QUAD CITIES NUCLEAR POWER STATION, UNIT 2

Amendment No. 80  
License No. DPR-30

ATTACHMENT TO LICENSE AMENDMENT NO. 80

SAFETY EVALUATION BY THE OFFICE OF NUCLEAR REACTOR REGULATION

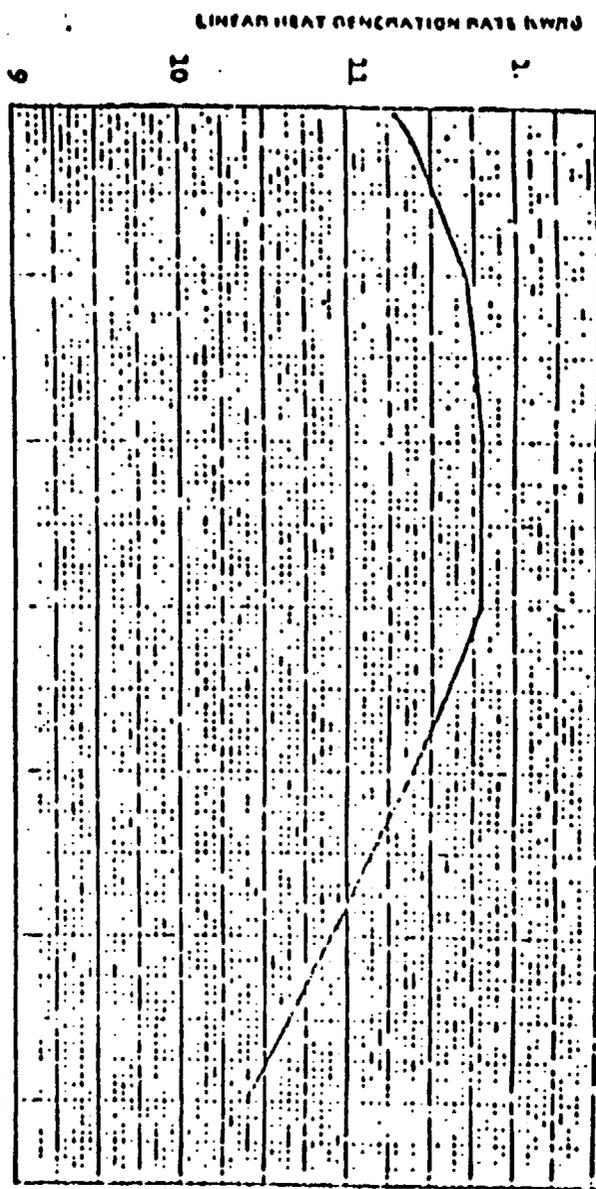
K. Minimum Critical Power Ratio (MCPR)

During steady-state operation at rated core flow, MCPR shall be greater than or equal to:

$$1.34 \text{ for } T_{ave} \leq 0.73 \text{ secs}$$

$$1.39 \text{ for } T_{ave} \geq 0.86 \text{ secs}$$

$$0.385 T_{ave} + 1.059 \\ \text{for } 0.73 < T_{ave} < 0.86 \text{ secs}$$

The licensee's request is for an amendment to reduce the TS limit MCPR from the current value of 1.37 to 1.34. This new value is more conservative than the value of 1.32 resulting from the analysis of the most limiting transient for Cycle 7, but still provides the desired improved operating margin.

We have reviewed the licensee's submittal (Reference 1) and the appropriate parts of the reference document (Reference 5). The supporting analysis was performed by GE using previously approved methodology and models (Reference 4). We find the proposed change in operating limit MCPR to be acceptable.

Figure 3.5-1  
 (Sheet 3 of 5)  
 Maximum Average Planar Linear Heat Generation Rate (kW/m) vs. Planar Average Exposure

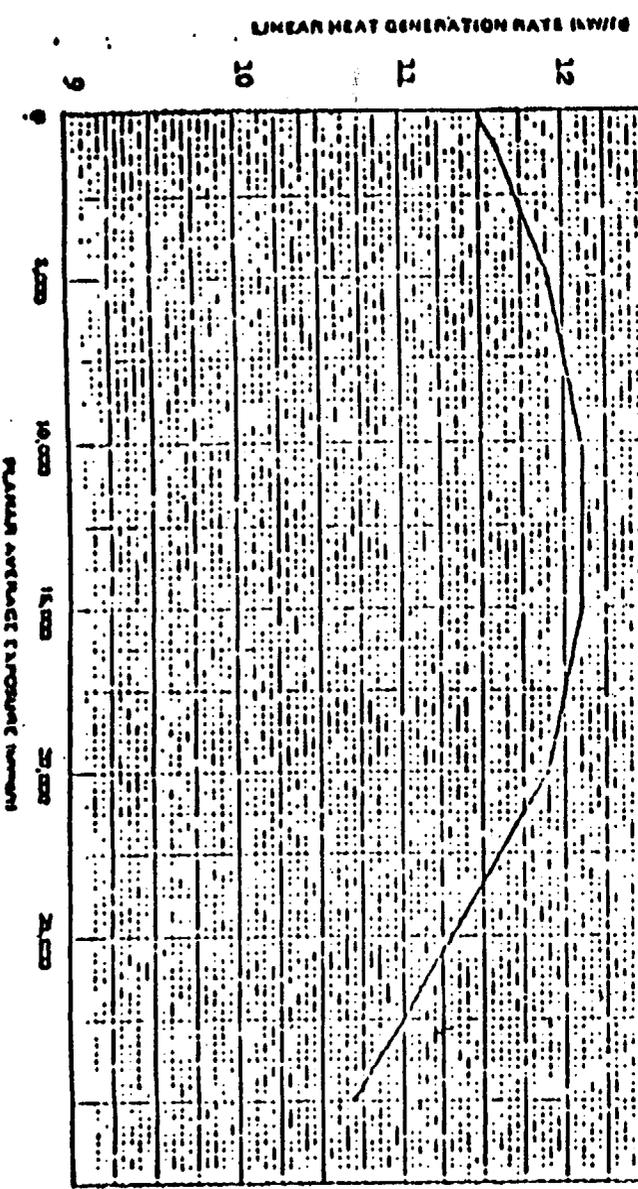
This amendment (1) reduces the current minimum critical power ratio (MCPR) operating limit to provide additional operating margin during the upcoming operating cycle, (2) explicitly applies a maximum average planar linear heat generation rate (MAPLHGR) curve to a fuel type to be used in the upcoming operating cycle, and (3) changes the pressure setpoints for three safety-relief valves as a result of Mark I containment modifications.

Fig. 3.5-1, Sheet 3

The reference document containing the ECCS analysis for Quad Cities Units 1 and 2 has previously been approved by the NRC staff and continues to be the basis for MAPLHGR limits for fuel types used in these units (Reference 5). This document has been updated as appropriate for other fuel types by issuance of Errata and Addenda to Reference 5. Barrier fuel type BP8DRB265H will be used in the core for the upcoming operating cycle. This fuel is of the same nuclear design as non-barrier fuel type P8DRB265L, which has previously been approved for use in Quad Cities Unit 2. Since the two fuel types are of the same nuclear design, the MAPLHGR curve for the previously approved fuel type P8DRB265L applies also to barrier fuel type BP8DRB265H, as documented by GE in Errata and Addenda No. 10 to Reference 5, and the licensee's request to incorporate this into their Technical Specifications is acceptable.
